SERVICE BULLETIN

Equipment: GranuFlo® II
Bulletin: 05-GRN-004 Rev. A
Subject: Software Update

Originated By (Dept):	Reviewed By:	Approved By:	Effective Date:
J. Fox (TSD)	Brooks E. Rogers	ECO# 17518	12/29/05

Figure 3

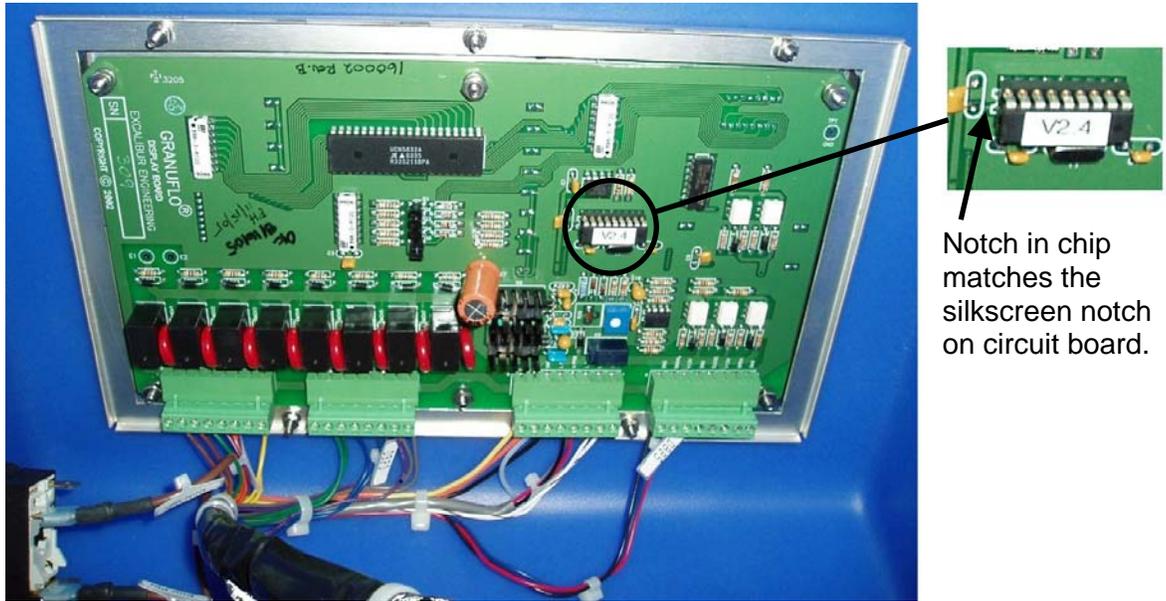
Under certain pressure and valve combinations, the process of closing valves may cause the valves to chatter. To eliminate the valve chatter, the software program has been modified to change the process of when valves are closed. Since it is difficult to determine if or when a GranuFlo® II will experience this valve chatter, Fresenius recommends updating the software to version 2.7 or later (P/N 160010).

- Using a chip pulling tool, locate and carefully remove the software chip from the controller board. See Figure 3 for location and chip orientation.

- Using the notch in the chip as reference (see Figure 3), install the new software chip into the now empty socket on the controller board. When inserting the chip, take care that none of the pins bend or miss their respective socket hole.
- Once the new software chip has been installed, cut the temporary tie-wrap and reposition the vertical blue shroud into place.
- Carefully realign the holes in the shroud so they line up with the existing holes in the metal support plate.
